ZONING CHANGE REVIEW SHEET

CASE: C814-2014-0110.02.SH

ADDRESS: 7900 Loyola Lane
Austin, Texas 78724

Project Name and Proposed Use: 7900 Loyola Lane. C814-2014-0110.02.SH. Project: Colony Park Sustainable Community Initiative PUD. A PUD amendment on 208 acres of land to update the Land Use Plan, permitted uses, maximum densities and site development regulations. Related item: Council Resolution # 20230608-053. Amend the Colony Park Plan to make it less prescriptive by: Restructuring the PUD to be more flexible and less prescriptive to better respond to unforeseen opportunities and changing market conditions and to adapt to the 2020 Land Use Plan. Reconfiguring the buffer areas and setbacks for the Critical Environmental Features (CEFs) to create a more cohesive and efficient land use plan. Reducing the number of street sections and bringing them into alignment with the Transportation Criteria Manual. Refining parking requirements to bring them into conformance with current market conditions. Adding Equitable Transit-Oriented Development. Making adjustments to the Open Space Plan, while maintaining a minimum of 41.63 acres (20% of the site) in parks and open spaces. Refining parki

EXHIBIT G (PAGE 3)

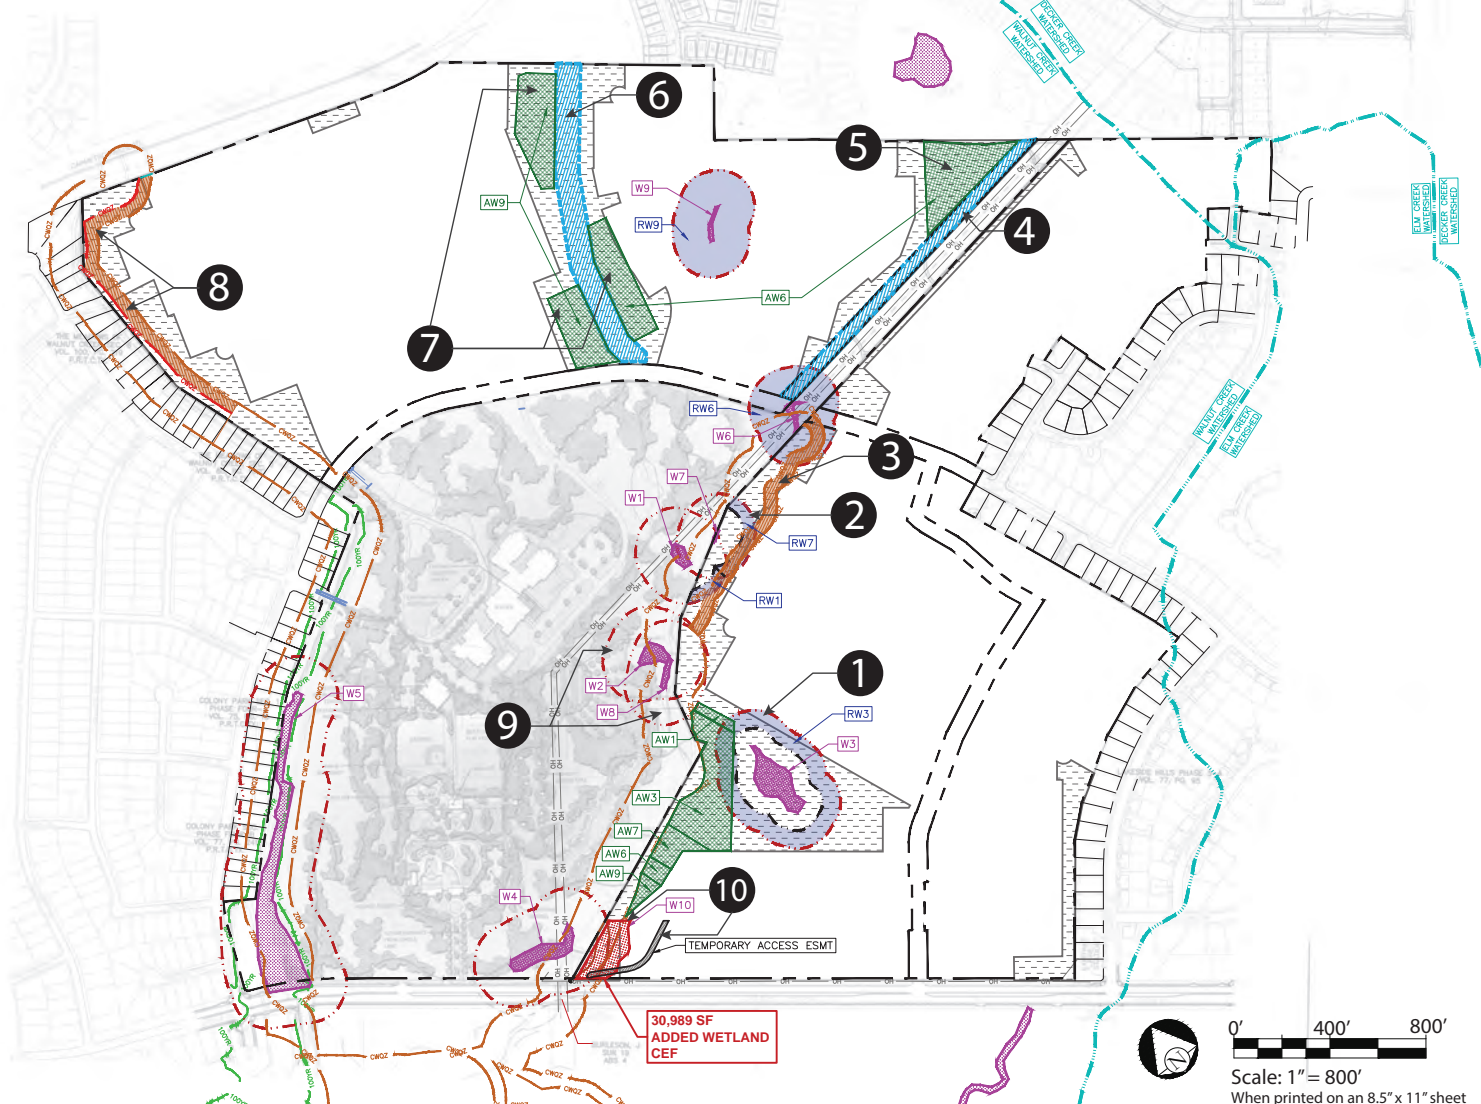
EV 16 Revise note #8, Exhibit G (page 3) as shown.

- “Grading with revegetation” sounds like a grass-lined channel. If this is the intention, it needs to be designed with WPD so that it mimics the features of a natural channel, including sinuosity and all the things listed in note #12, Exhibit G (page 3) – “...The restoration would at a minimum need to provide grade control structures that stabilize the channels and include the installation of check dams, cobble riffles, seepage berms, and in-stream installation of root wads and large woody debris.”

EXHIBIT H COLONY PARK P.U.D. OPEN SPACE PLAN

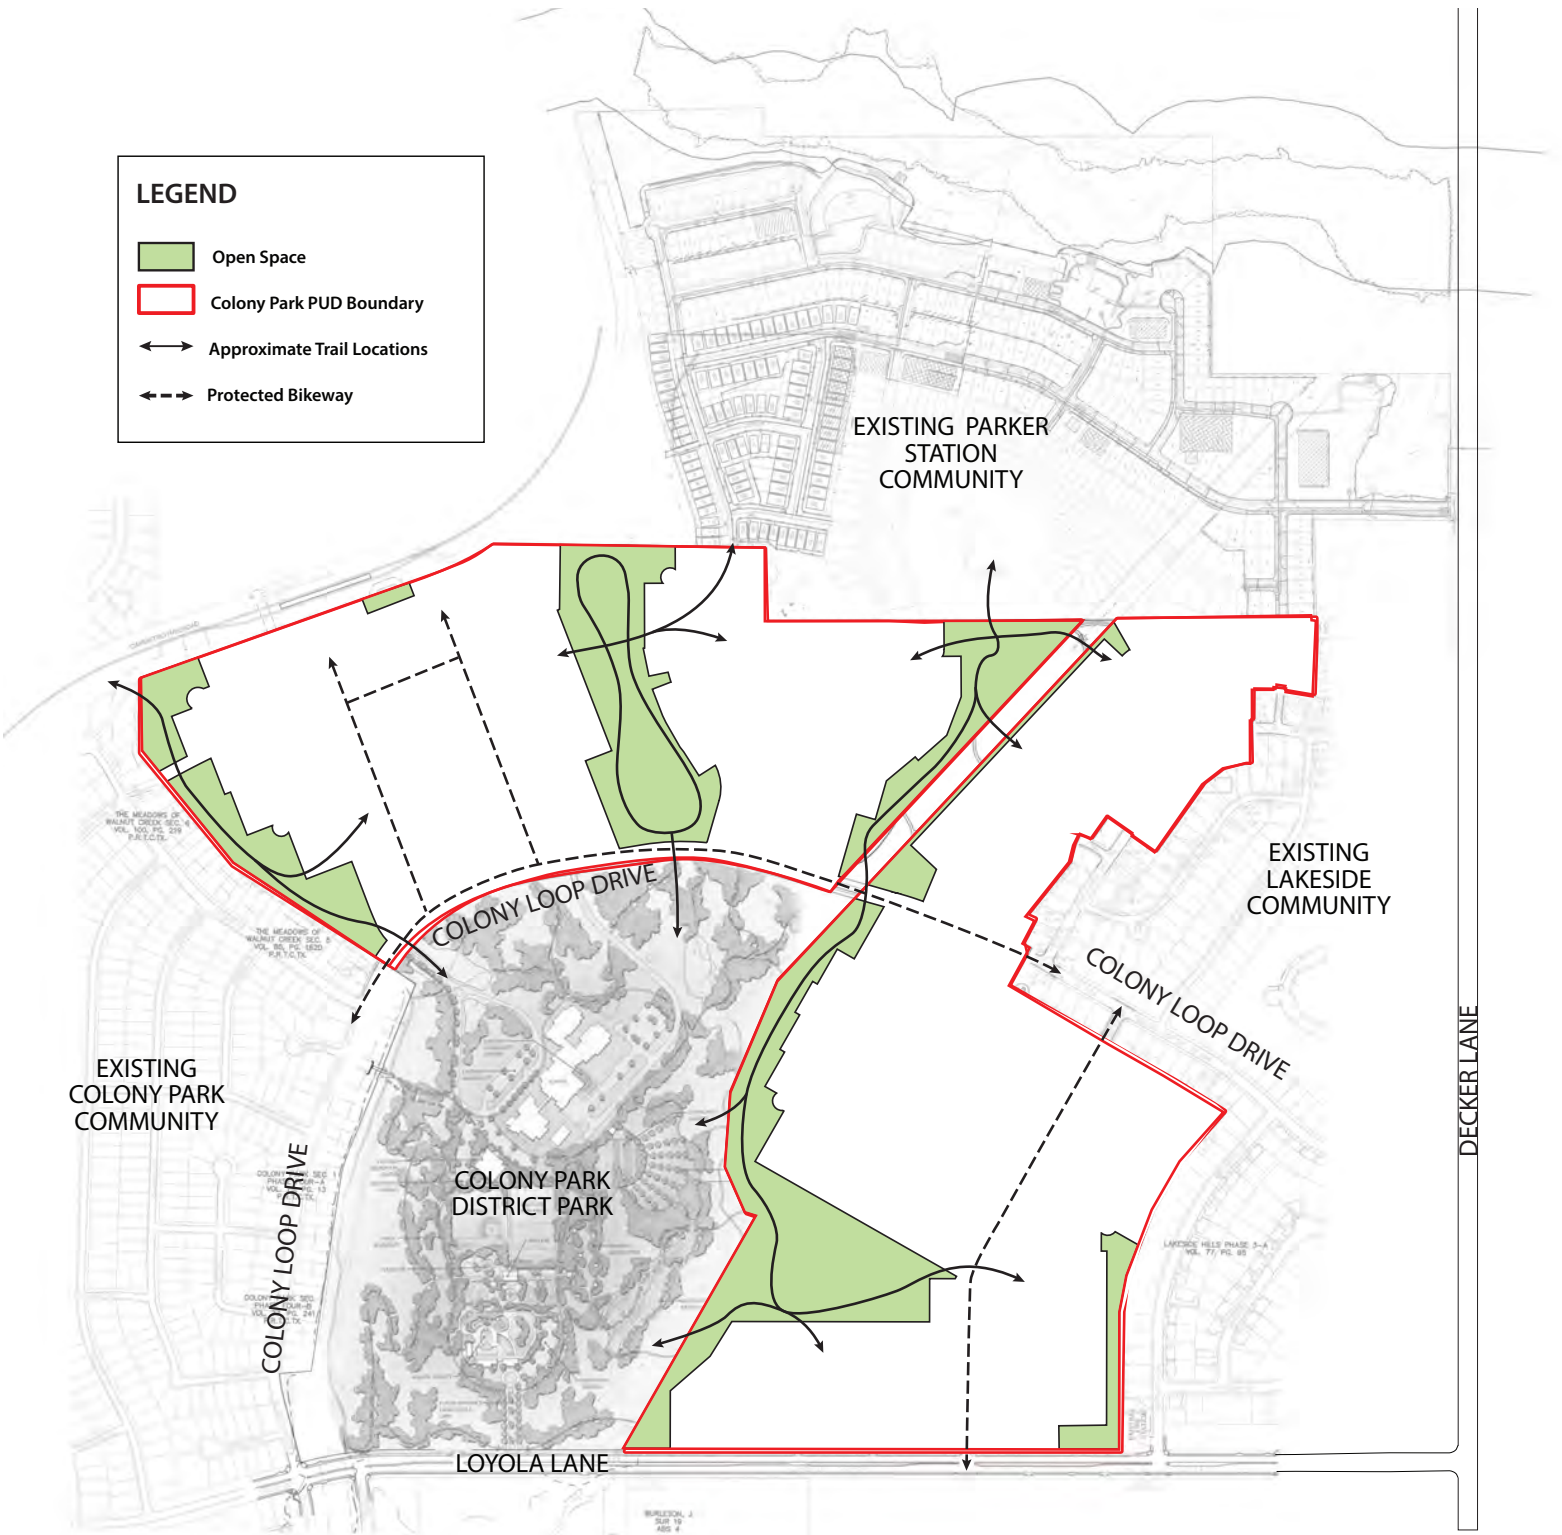
U1: Note explicitly on the parks and open space plan, environmental exhibits, and in code modifications that the parks amenities contemplated are allowed by right within the open space areas, with the exception of the wetland identified by the environmental reviewer in the southern portion of OS-1, south of the convergence of the creeks; divide OS-1 into two OS areas, OS-1 and OS-1.1 (for the southern area just noted along the Central Health site), and denote restrictions to amenities within OS-1.1.

Colony Loop Drive

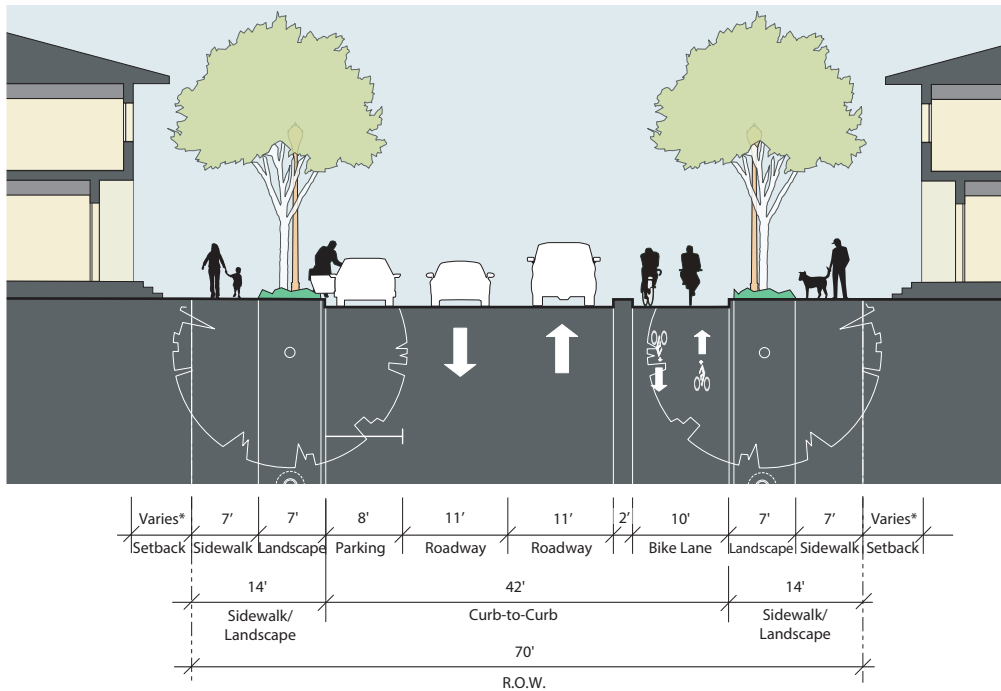
U2: Comment cleared. Please note the discrepancy between the 70' ROW identified under Exhibit I (pg. 28) and a 72' Colony Loop Drive cross section shown Exhibit I (pg. 30). ATD recommends the 72' ROW, consistent with the ASMP, and revising bike facility to the TCM recommended 10' minimum, which the applicant had previously agreed to.

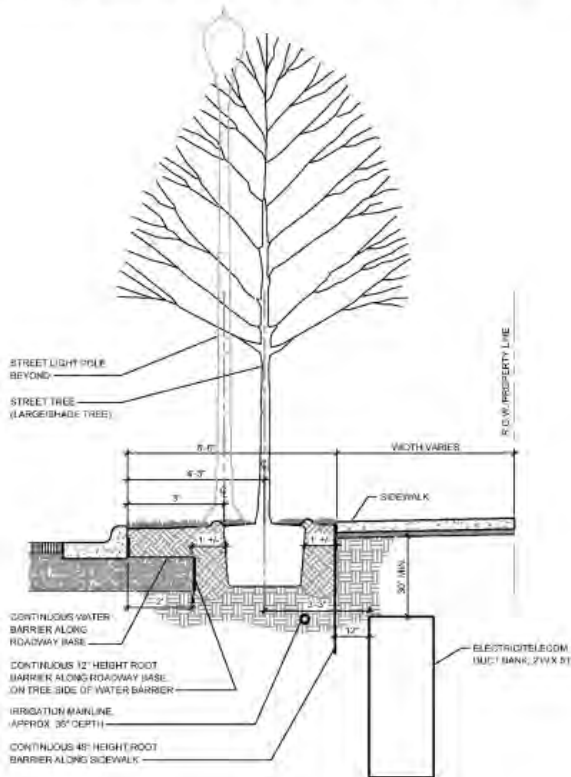
Note: The U2 Draft PUD (Pg. 40) Exhibit K – F. Special Detail has the correct detailed attached. It depicts the solution AE and other COA utilities agreed upon moving AE facilities within the roadway.

- The U2 Exhibit K edits 9/25/23 and U2 Exhibit K Final 9/25/23 have the incorrect “F. Special Detail” attached. Please replace to match the one shown/provided in the U2 Draft PUD.
- Incorrect detail:

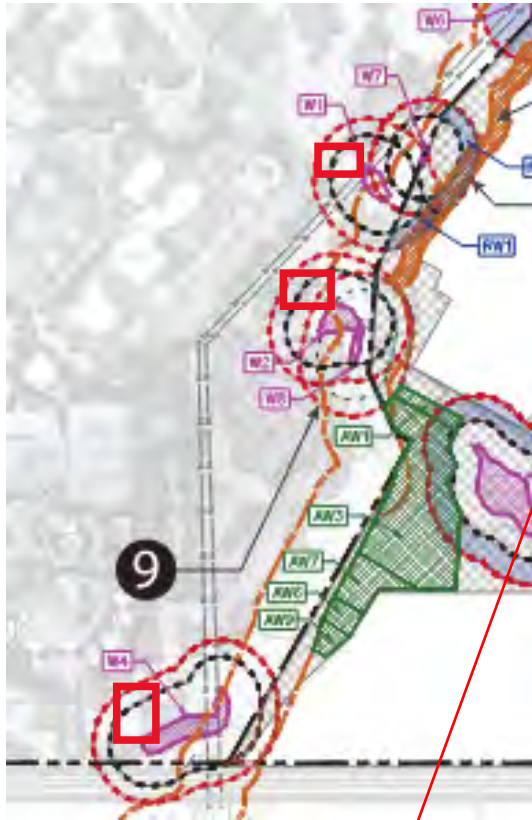
3. Please remove any extraneous line work from the exhibit unless it indicates a reduction or addition of area (see example below showing red X's).
